Proposal for 02 series of amendments to Regulation No. 129 (Enhanced Child Restraint Systems)

Submitted by the Working Party on Passive Safety *

02 series of amendments to Regulation No. 129 (Enhanced Child Restraint Systems (ECRS))

Figure 1
Load cell positions

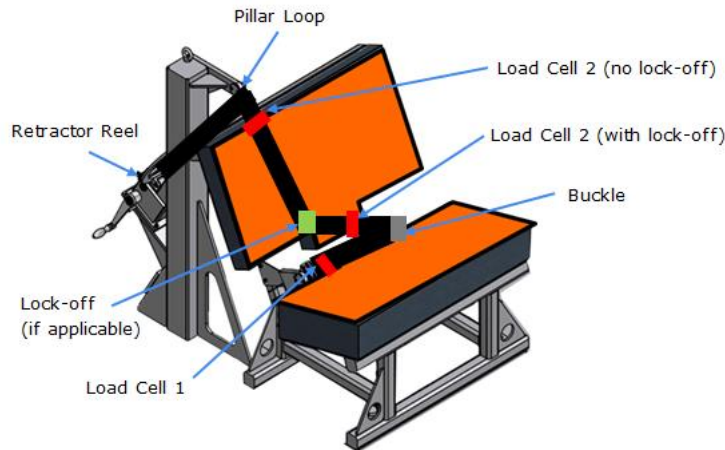
Fit load cell 1 to the outboard position as shown Figure 1. Install the Enhanced Child Restraint System in the correct position. If a lock-off device is fitted to the Enhanced Child Restraint System and acts upon the diagonal belt, place load cell 2 at a convenient position behind the Enhanced Child Restraint System between the lock-off device and the buckle as shown above. If no lock-off device is fitted or if the lock-off device is fitted at the buckle, position the load cell at a convenient position between the pillar loop and the Enhanced Child Restraint System.

Adjust the lap portion of the reference belt to achieve a tension load of $50 \text{ N} \pm 5 \text{ N}$ at load cell 1. Make a chalk mark on the webbing where it passes through the simulated buckle.

While maintaining the belt at this position, adjust the diagonal to achieve a tension of $50 \text{ N} \pm 5 \text{ N}$ at load cell 2 by either locking the webbing at the Enhanced Child Restraint System webbing locker or by pulling the belt between the belt clamping mechanism and the standard retractor. If the tension in load cell 2 is achieved by pulling the belt between the clamping mechanism and the retractor, the clamping mechanism shall now be locked.

Extract all webbing from the retractor spool and rewind the excess webbing keeping a tension of $4 \pm 3 \text{ N}$ in the belt between the retractor and the pillar loop. The spool shall be locked before the dynamic test. Conduct the dynamic crash test.

Arrangements of the approval mark

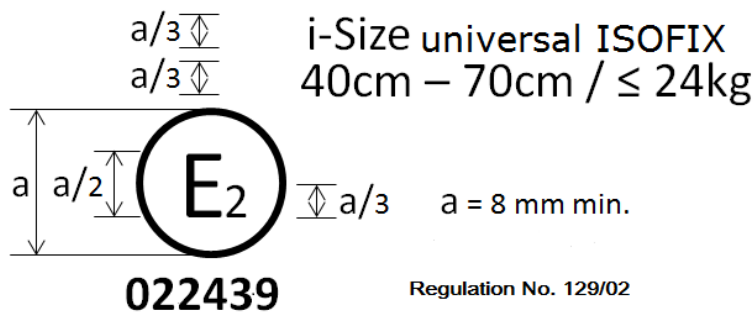
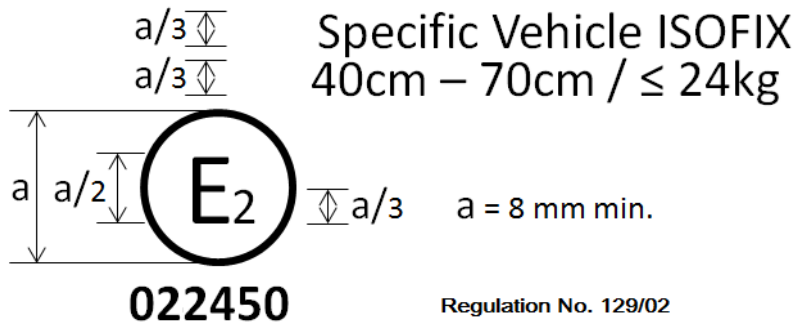
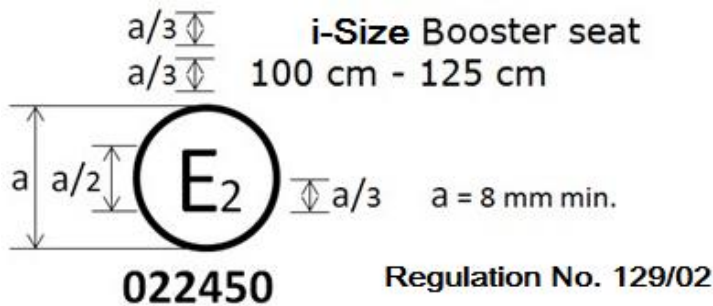
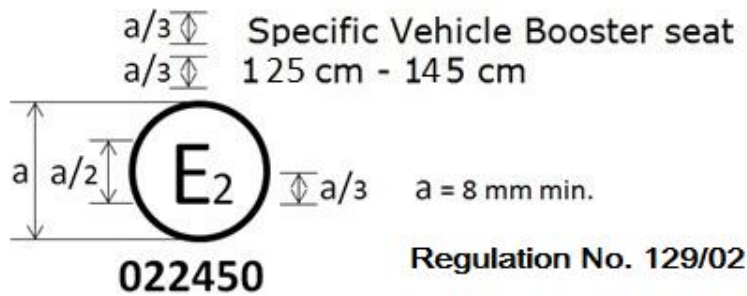
The Enhanced Child Restraint System bearing the above approval mark is a device capable of being fitted in any i-size seating position of the vehicle and of being used for the 40 cm - 70 cm size range and mass limit of 24 kg; it is approved in France (E 2) under the number 022439. The approval number indicates that the approval was granted in accordance with the requirements of the Regulation concerning the approval of Enhanced Child Restraint Systems used on-board of motor vehicles as amended by the 02 series of amendments. In addition the name of the regulation has to be identified on the approval

The Enhanced Child Restraint System bearing the above approval mark is a device not capable of being fitted in every vehicle and capable of being used for the 40 cm - 70 cm size range and mass limit of 24 kg; it is approved in France (E 2) under the number 022450. The approval number indicates that the approval was granted in accordance with the requirements of the Regulation concerning the approval of Specific vehicle ISOFIX Enhanced Child Restraint Systems used on-board of motor vehicles as amended by the 02 series of amendments. In addition the name of the regulation has to be identified on the approval mark followed by the series of amendment according to which the approval has been granted.

The Enhanced Child Restraint System bearing the above approval mark can be fitted in any i-Size booster seating position and used for the 100 cm - 125 cm size range; it is approved in France (E 2) under the number 022450. The approval number indicates that the approval was granted in accordance with the requirements of the Regulation concerning the approval of Enhanced Child Restraint Systems used on-board of motor vehicles as amended by the 02 series of amendments. In addition, the name of the regulation is to be identified on the approval mark followed by the series of amendment according to which the approval has been granted.

The Enhanced Child Restraint System bearing the above approval mark is a device not capable of being fitted in every vehicle but capable of except being used for the 125 cm - 145 cm size range; it is approved in France (E 2) under the number 022450. The approval number indicates that the approval was granted in accordance with the requirements of the Regulation concerning the approval of specific vehicle booster seat Enhanced Child Restraint Systems used on-board of motor vehicles as amended by the 02 series of amendments. In addition the name of the Regulation needs to be identified on the approval mark followed by the series of amendment according to which the approval has been granted.

In case the ECRS is equipped with a module, the size range is not on the approval mark but on the module mark.

Arrangements of the approval mark in combination with a module mark

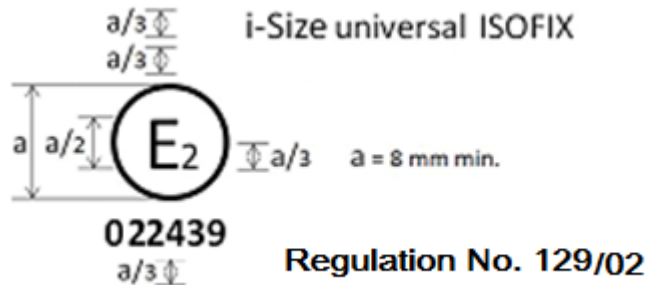
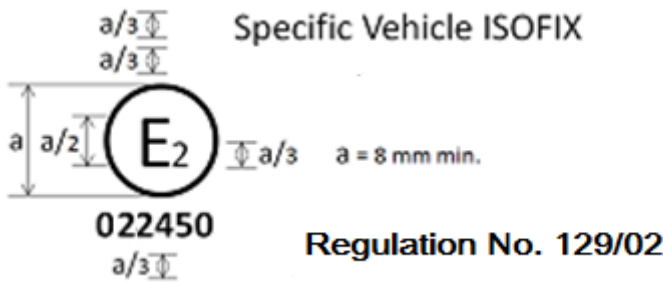
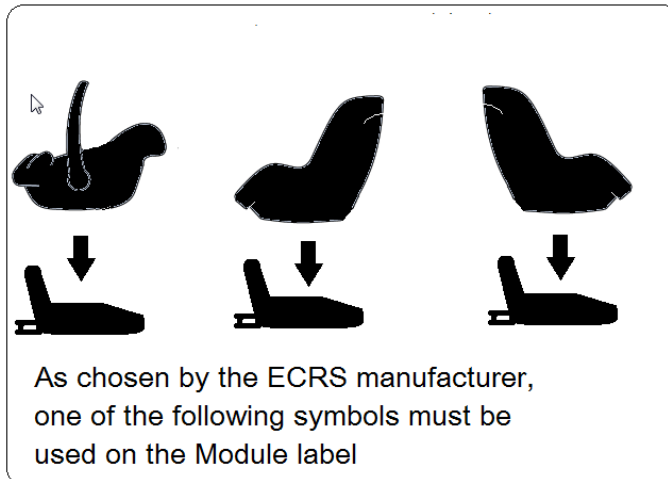
The Enhanced Child Restraint System bearing the above approval mark is a device, including module(s), capable of being fitted in any i-size compatible vehicle seating position. It is approved in France (E 2) under the number 022439. The approval number indicates that the approval was granted in accordance with the requirements of the Regulation concerning the approval of Enhanced Child Restraint Systems used on-board of motor vehicles as amended by the 02 series of amendments. In addition the name of the regulation has to be identified on the approval mark followed by the series of amendment according to which the approval has been granted.

The Enhanced Child Restraint System bearing the above approval mark is a device, including module(s), not capable of being fitted in every vehicle. It is approved in France (E 2) under the number 022450. The approval number indicates that the approval was granted in accordance with the requirements of the Regulation concerning the approval of Specific vehicle ISOFIX Enhanced Child Restraint Systems used on-board of motor vehicles as amended by the 02 series of amendments. In addition the name of the regulation has to be identified on the approval mark followed by the series of amendment according to which the approval has been granted.

The Enhanced Child Restraint System module bearing the above module mark capable of being used for the 40 cm - 70 cm size range and mass limit of 24 kg; it is approved under the number 022439 to be used in combination with device approved according to Regulation No. 129 under the same number 022439. The approval number

Figure 1

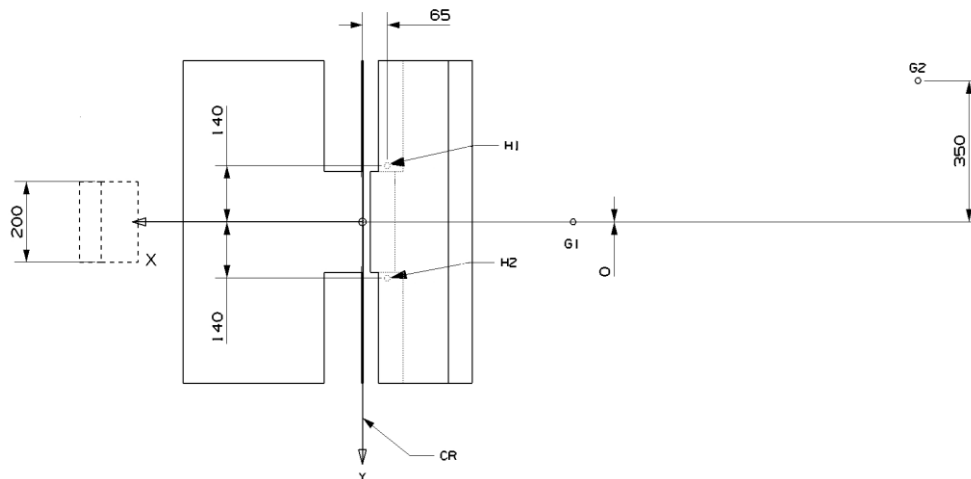
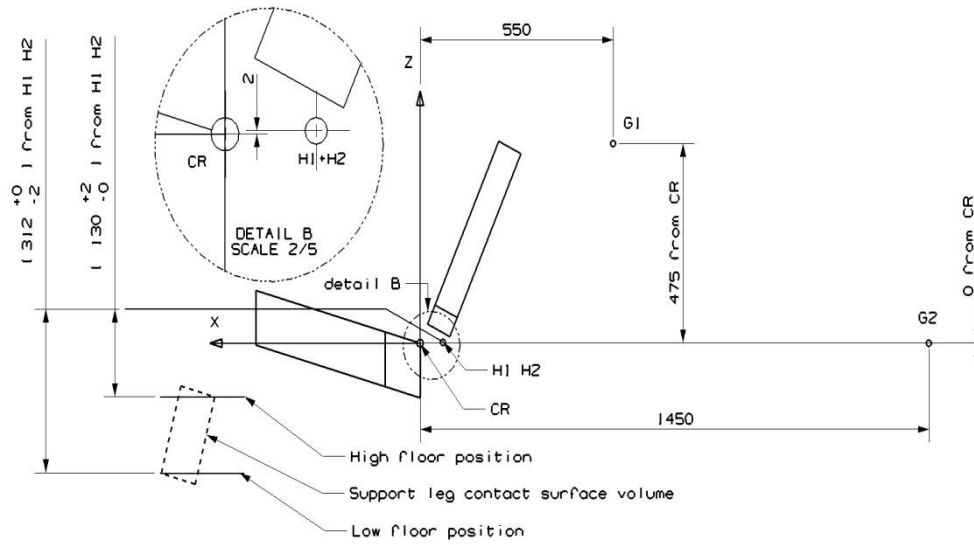
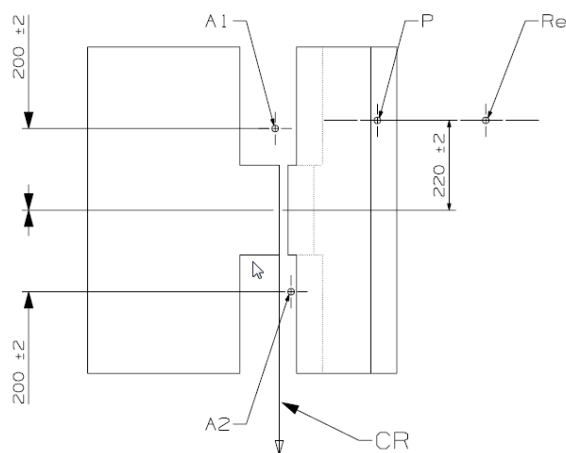
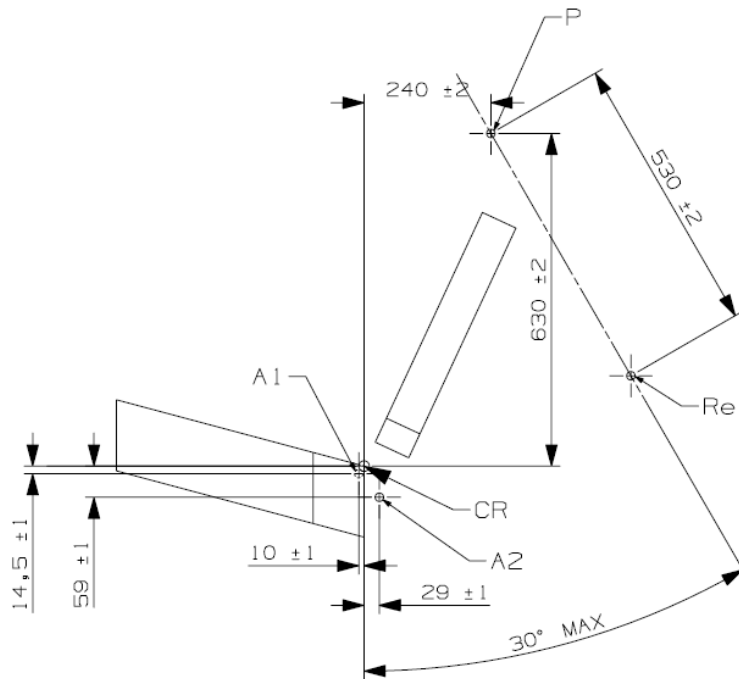
1. The anchorages shall be positioned as shown in the figure below.
2. Enhanced Child Restraint Systems in the i-Size universal, specific and restricted categories shall use the following anchorage points: H₁ and H₂.

3. For testing of Enhanced Child Restraint Systems with top tether, the anchorage G₁ or G₂ shall be used.
4. In the case of Enhanced Child Restraint Systems utilising a support-leg, the Technical Service shall select the anchorages to be used according to paragraph 3. above and with the support-leg adjusted as specified in paragraph 7.1.3.6.3. of this Regulation.

5. The structure carrying the anchorages shall be rigid. The upper anchorages shall not be displaced by more than 0.2 mm in the longitudinal direction when a load of 980 N is applied to them in that direction. The trolley shall be so constructed that no permanent deformation shall occur in the parts bearing the anchorages during the test.

Direction	Upper Anchorage (P)			Buckle (A2)			Lower outer (A1)		
	X	Y	Z	X	Y	Z	X	Y	Z
Distance (mm)	-240	-220	-630	-29	200	59	10	-200	14.5

Figure 1

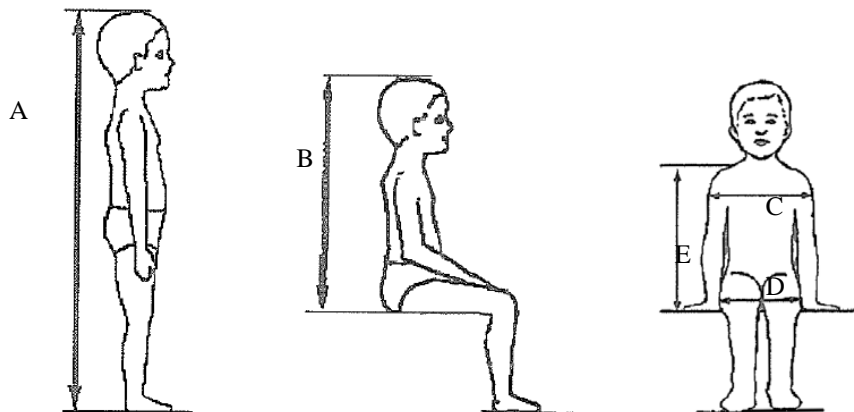
<i>Stature cm</i>	<i>Minimum Sitting height cm</i>	<i>Minimum Shoulder breadth cm</i>	<i>Minimum Hip breadth cm</i>	<i>Minimum Shoulder height cm</i>	<i>Maximum Shoulder height cm</i>
<i>A</i>	<i>B</i>	<i>C</i>	<i>D</i>	<i>E1</i>	<i>E2</i>
	<i>95%ile</i>	<i>95%ile</i>	<i>95%ile</i>	<i>5%ile</i>	<i>95%ile</i>
≤ 40				≤ 27.4	
45	39.0	12.1	14.2	27.4	29.0
50	40.5	14.1	14.8	27.6	29.2
55	42.0	16.1	15.4	27.8	29.4
60	43.5	18.1	16.0	28.0	29.6
65	45.0	20.1	17.2	28.2	29.8
70	47.1	22.1	18.4	28.3	30.0
75	49.2	24.1	19.6	28.4	31.3
80	51.3	26.1	20.8	29.2	32.6
85	53.4	26.9	22.0	30.0	33.9
90	55.5	27.7	22.5	30.8	35.2
95	57.6	28.5	23.0	31.6	36.5
100	59.7	29.3	23.5	32.4	37.8
105	61.8	30.1	24.9	33.2	39.1
110	63.9	30.9	26.3	34.0	40.4
115	66.0	32.1	27.7	35.5	41.7
120	68.1	33.3	29.1	37.0	43.0
125	70.2	33.3	29.1	38.5	44.3
130	72.3	33.3	29.1	40.0	46.1
135	74.4	33.3	29.1	41.5	47.9
140	76.5	34.2	29.6	43.0	49.7
145	78.6	35.3	30.8	44.5	51.5
150	81.1	36.4	32.0	46.3	53.3

Figure 1
Standard seat belt configurations

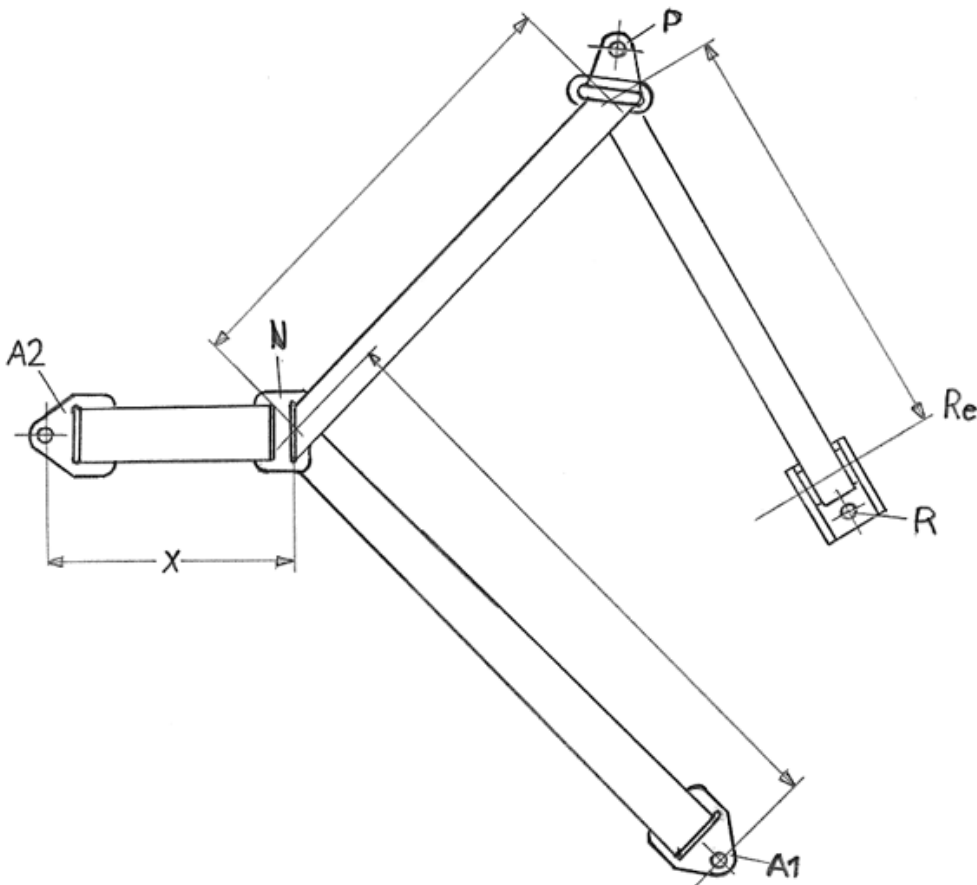
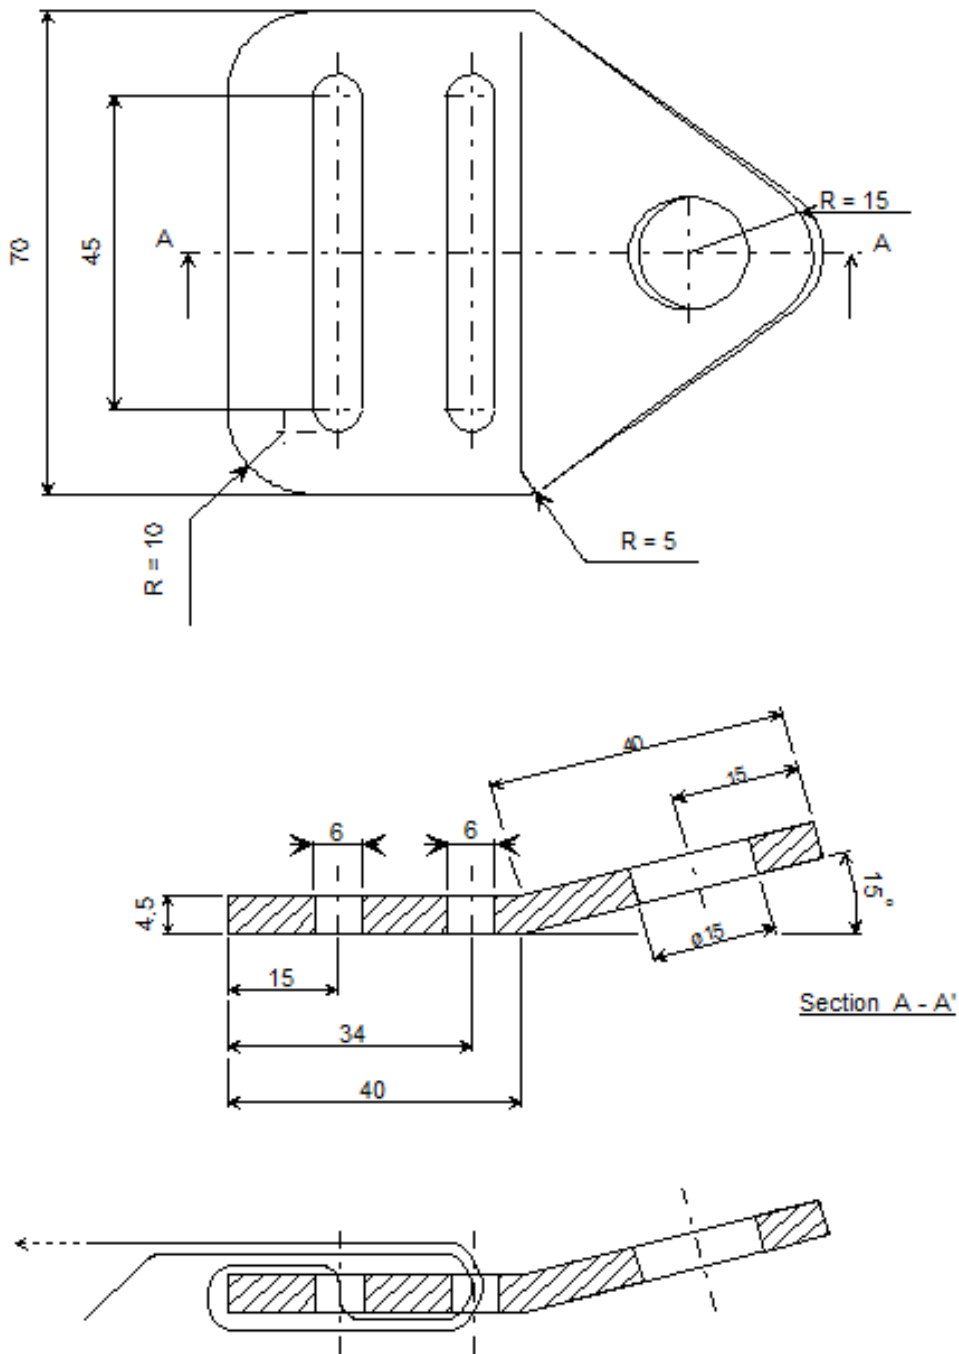
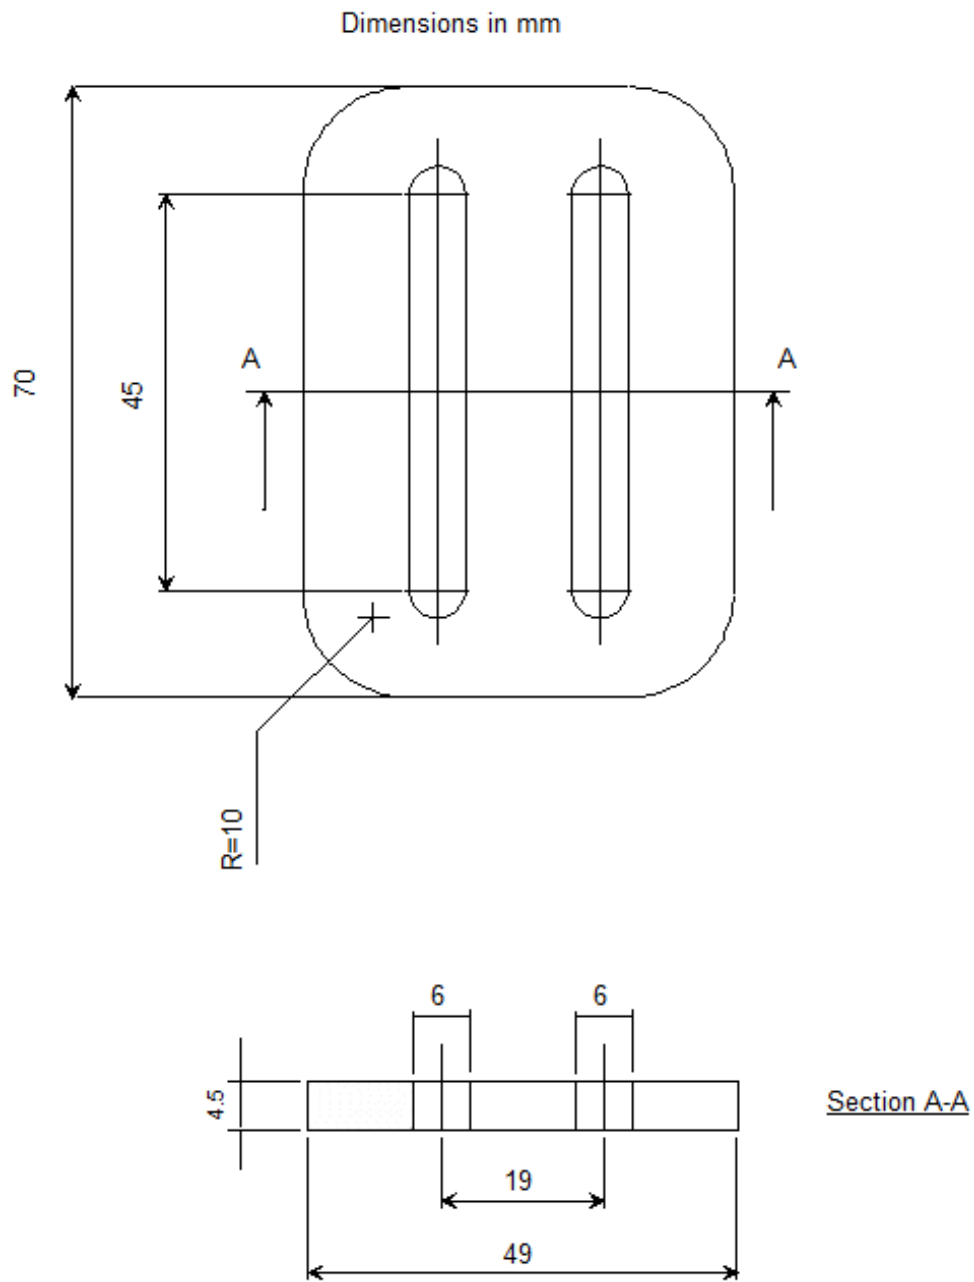
1. The safety-belt for the dynamic test and for the maximum length requirements shall be made according to the configuration shown in Figure 1. These are a three-point retracting belt system.

2. The three-point retracting belt has the following rigid parts: a retractor (R), a pillar loop (P), two anchorage points (A1 and A2) (see Figure 1), and a central part (N, in detail in Figure 3). The retractor shall comply with the requirements of Regulation No. 16 (paragraph 6.2.5.2.2.) for retraction force. The retractor spool diameter is 33 ± 0.5 mm (example is given in Mutual Resolution No. 1 (M.R.1)).

3. The retracting belt shall be fitted to the anchorages on the test bench, described in Annex 6, Appendix 2 as follows:
 - (a) Belt anchorage A1 shall be fitted to trolley anchorages B0 (outboard);

- (b) Belt anchorage A2 shall be fitted to trolley anchorage A (inboard);
 - (c) Belt pillar loop P shall be fitted to trolley anchorage C;

- (d) Belt retractor R shall be fitted to trolley anchorage such that the spool centre line is positioned on Re.

The value of X in Figure 1 below is 200 ± 5 mm. The effective strap length between A1 and the centre line of the retractor spool Re (when the webbing is fully extracted including the minimum length of 150 mm for testing of Enhanced Child Restraint System shall be $2,820 \pm 5$ mm when measured in a straight line without load and on a horizontal surface. This length may be increased for the testing of restricted categories; for all categories with the Enhanced Child Restraint System installed, there shall be a minimum of 150 mm of strap length on the retractor spool.

- 4. The strap requirements for the belt as follows:
 - (a) Material: polyester spinnblack;
 - (b) Width: 48 ± 2 mm at 10,000 N;
 - (c) Thickness: 1.0 ± 0.2 mm;
 - (d) Elongation: 8 ± 2 per cent at 10,000 N.
